CITY OF DULUTH
Planning Division

STAFF REPORT

File Number	PL 14-123	Contact	Jenn Reed Moses, jmoses@duluthmn.gov	
Application Type	Variance	Planning Commission Date	September 9, 2014	
Deadline for Action	Application Date	August 15, 2014	60 Days	October 14, 2014
	Date Extension Letter Mailed	August 26, 2014	120 Days	December 11, 2014
Location of Subject	1300 block of East Skyline Parkway			
Applicant	George Hovland	Contact	218-310-2517, ghovland2@gmail.com	
Agent	N/A	Contact	N/A	
Legal Description	PID 010-0276-00030 and 010-0276-00040			
Site Visit Date	N/A	Sign Notice Date	August 26, 2014	
Neighbor Letter Date	August 26, 2014	Number of Letters Sent	55

Applicant is proposing a 24'x84' home with attached garage in the Skyline Parkway Overlay district that would occupy approximately 66% of the width of the lot (over the maximum 50% allows in the SP-O), have its long axis located parallel to Skyline Parkway (instead of within 20 degrees of perpendicular) and would be 25' from the front property line (half the distance of the 50' setback along the SP-O).

HOWLAND APPEAL
1328 E. SKYLINE
8-18-14

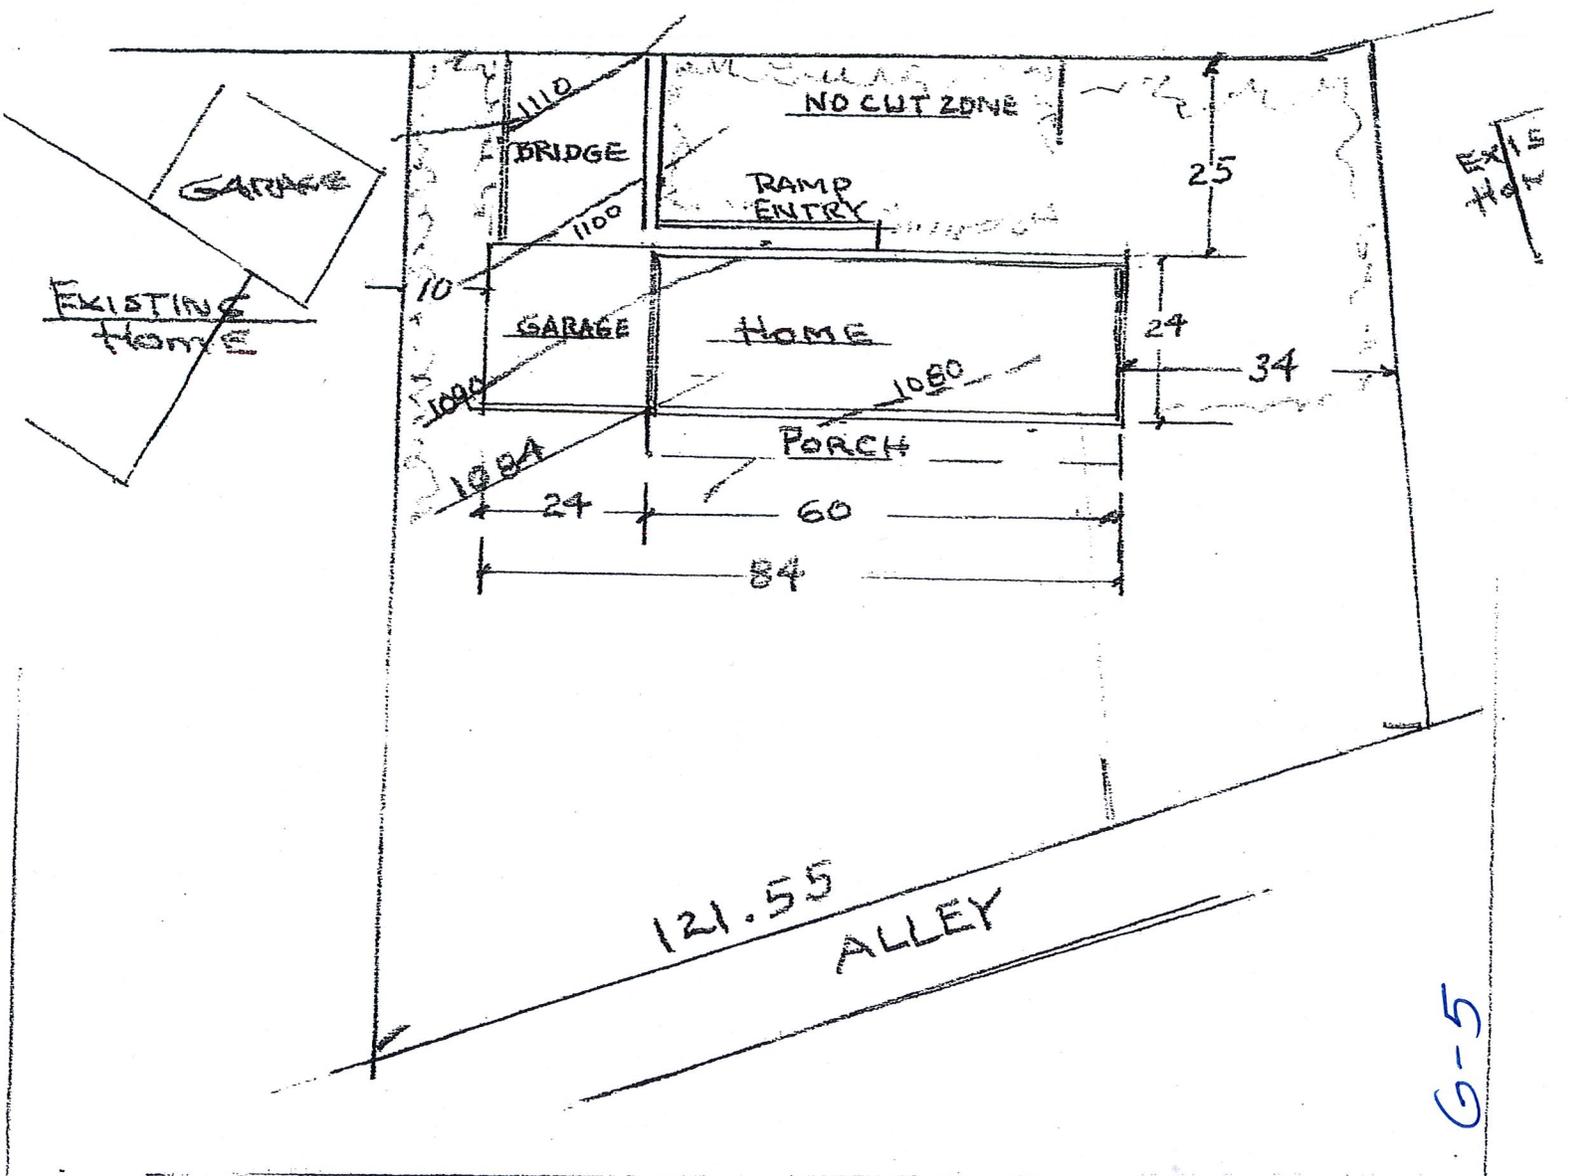
- 3.) The two parcels are undeveloped. After taking into consideration the setbacks of the SP-O and R-1 districts, a sizable buildable area remains that also is on the flattest portion of the lot. This suggests a variance is not needed for the preservation and enjoyment of a substantial property right. Application does not include information showing it is not feasible to build a house within the buildable area and therefore has not demonstrated the existence of a practical difficulty or undue hardship.

Staff recommends that the Planning Commission deny the variance to build a house within the Skyline Parkway Overlay that is a) 25' from the property line, b) covers approximately 66% of the lot width, and c) has the long axis parallel to the Parkway, for the following reasons:
